Re: 24 School Street, Wayland, MA, DEP file # 322-0897

RE: Order of Conditions for 24 School Street in Wayland

RE: 24 School Street

RE: 24 School Street, DEP file #322-0965

24 School Street, Wayland, MA - Groundwater Mounding using Soil Mottling

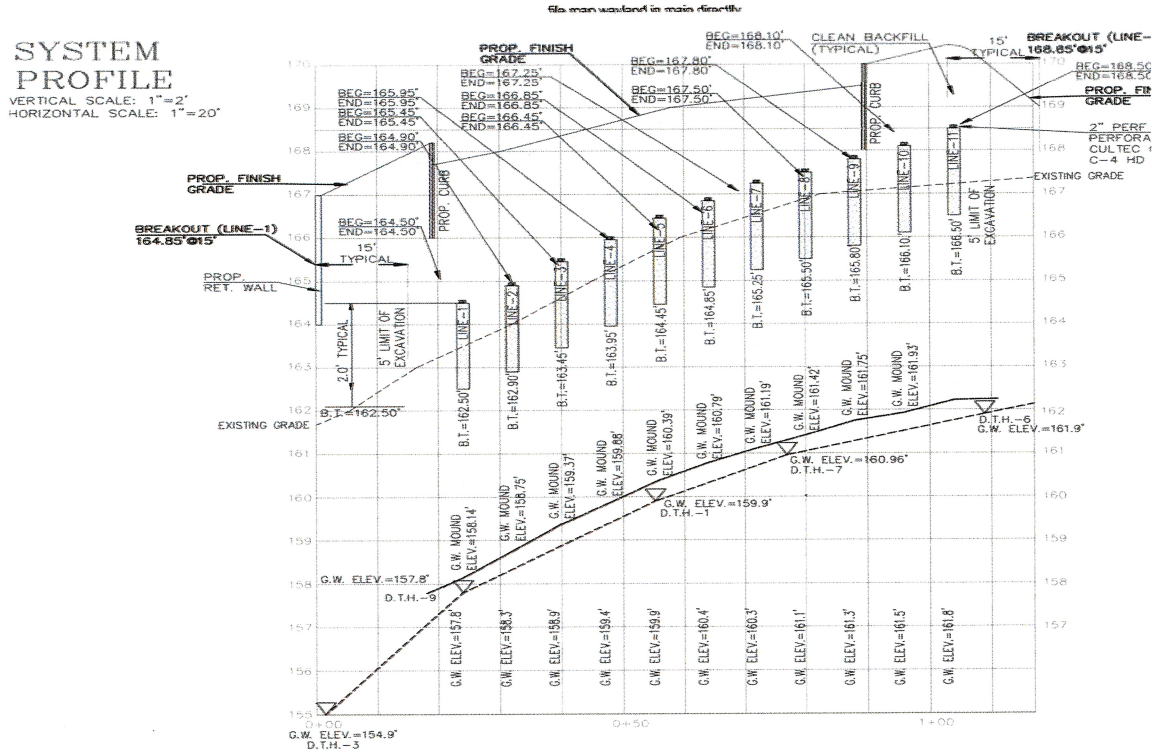
HGC's modeling results had more detailed spatial distribution of groundwater mounding while the maximum mounding heights in similar or slightly lower than CLawe's results. In some area, HGC's analysis showed a lightly higher mounded groundwater in the western 1/3 of the leaching area. The septic leaching trenches (Line-1, Line 2, Line-3, and Line-4) needs to be raised 0.08 ft to 0.67 ft. The septic plan will be updated with these elevation changes. However, it will not impact the surface grading as enough fill depth in this area can accommodate the new trench elevations. The HGC's analysis also confirmed that stormwater infiltration trench will be adequately

dewatered as the previously analysis done by CLAW. The detailed comparison of septic leaching field is summarized in the following. Detailed analysis can be referred to GHC's report.

3. This trench bottom elevation adjustments were done per the Wayland Board of Health request

5. Difference (-) indicate bottom of the trench need to be raised; (+) no change or can be lowered.

StreamStats Watershed Delineation

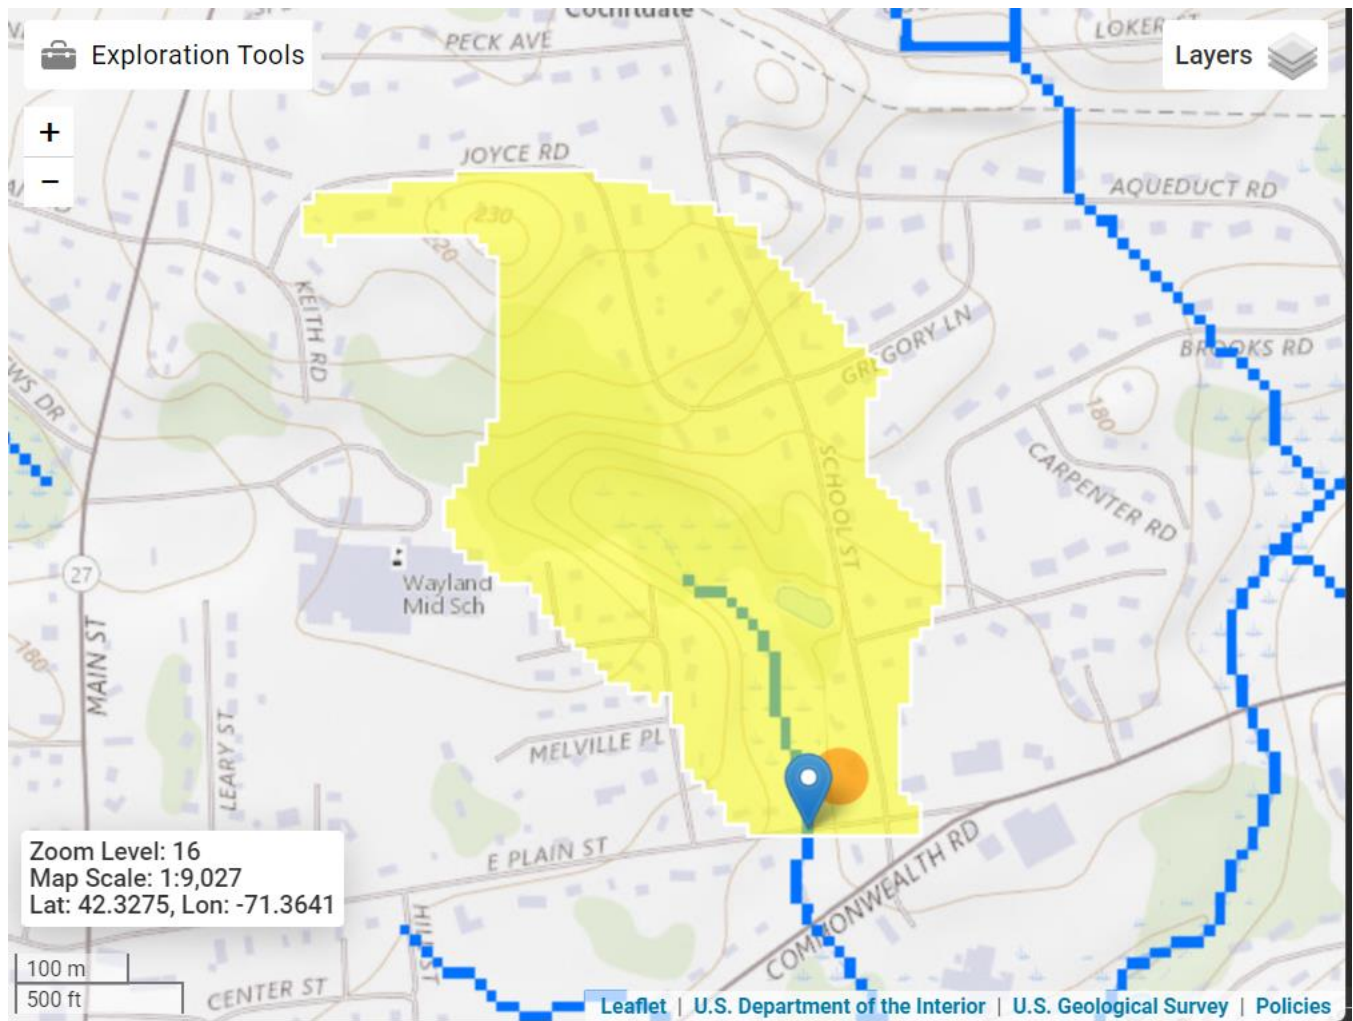
I note further that Mr. Wang's letter contains an apparent gross miscalculation as to how watershed sizes are determined. A proper calculation, according to Mr. Horsley, would show that the watershed is approximately .2 square miles, not the postage stamp size of .007 square miles that Mr. Wang's letter cites. Presumably a layperson would recognize by physical observation of the site that the figure of .007 is inaccurate. When the new delineation is conducted we would ask that the calculation of the watershed size be carefully reviewed by the Commission.

2. We rechecked USGS's watershed delineation map, we do not find "gross miscalculations" or mismapping of the watershed. As a registered professional engineer, I could not accuse that Mr. Horsley's 0.2 sq. miles watershed size contained "gross miscalculations" as Mr. Wiggins did not provide any supporting information to his letter for review. **Mr. Horsley is not a registered professional engineer in Massachusetts.** We reattached the USGS's watershed mapping from the StreamStats program for your reference.

Figure 1 - USGS Topographic Quadrangle 1970

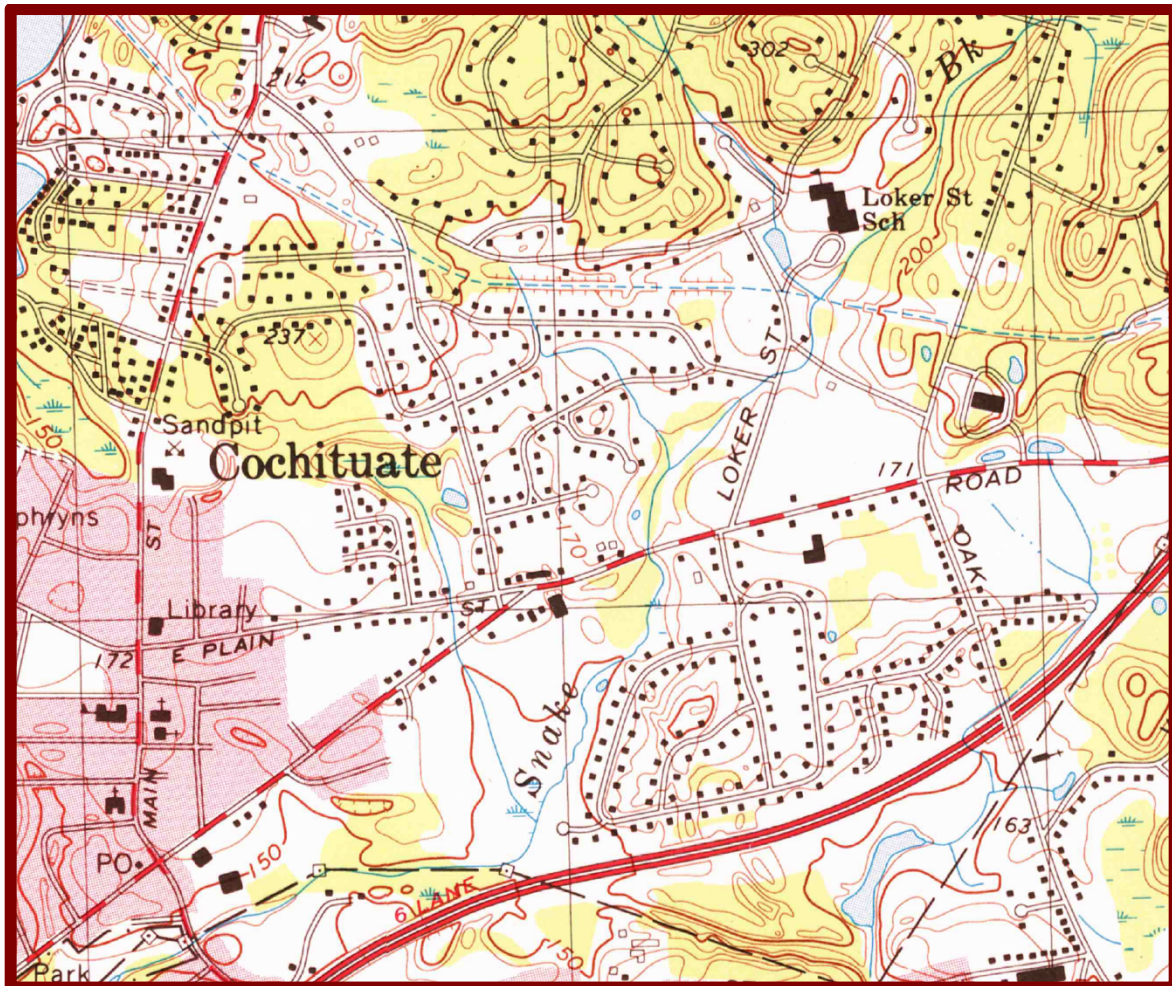
1. Perennial Stream and Riverfront Area. The Massachusetts Wetlands Protection Regulations provide for the protection of perennial streams and associated riverfront areas (310 CMR 58.00). Perennial streams include ***“streams that are perennial under natural conditions but are significantly affected by drawdowns of water supply wells.....or other human-made flow reduction shall be considered perennial”*** (310 CMR (2)(a)1f)– see attached excerpt from the regulations below.

Wayland Stream Analysis 071321

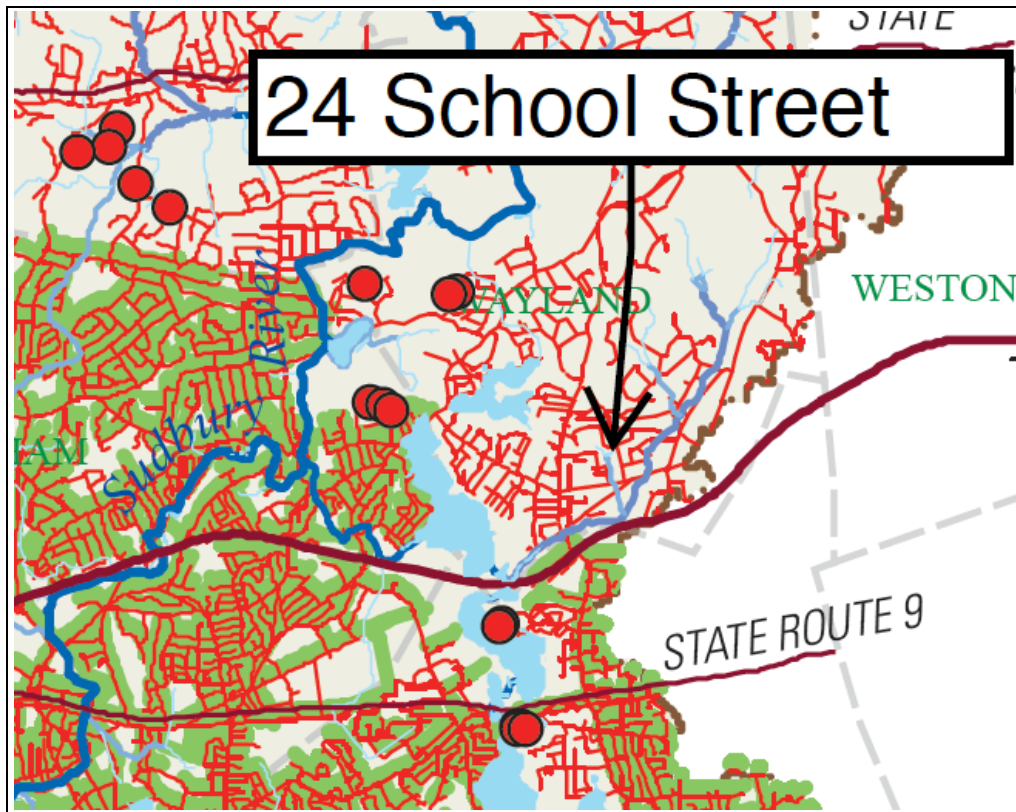
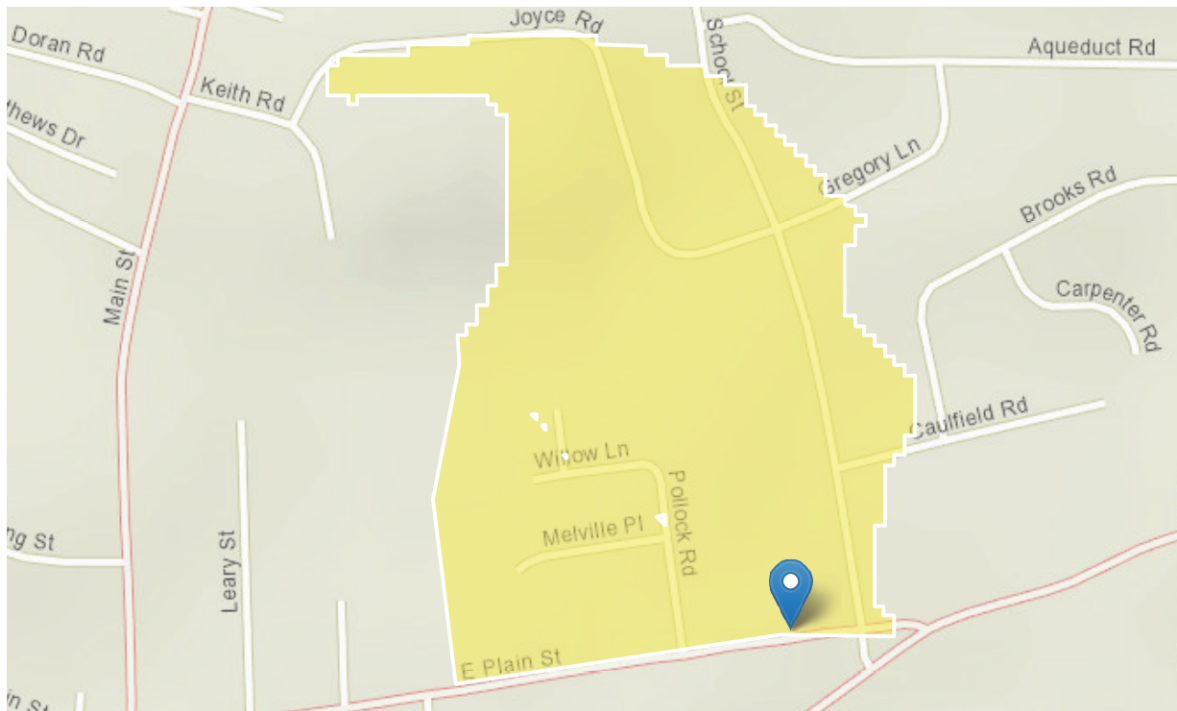
b) The USGS StreamStats analysis identifies the stream as having a perennial probability of 0.65 (over the 0.56 criterion). This information was not included with the peer reviewer’s (EcoTec) comment letter.
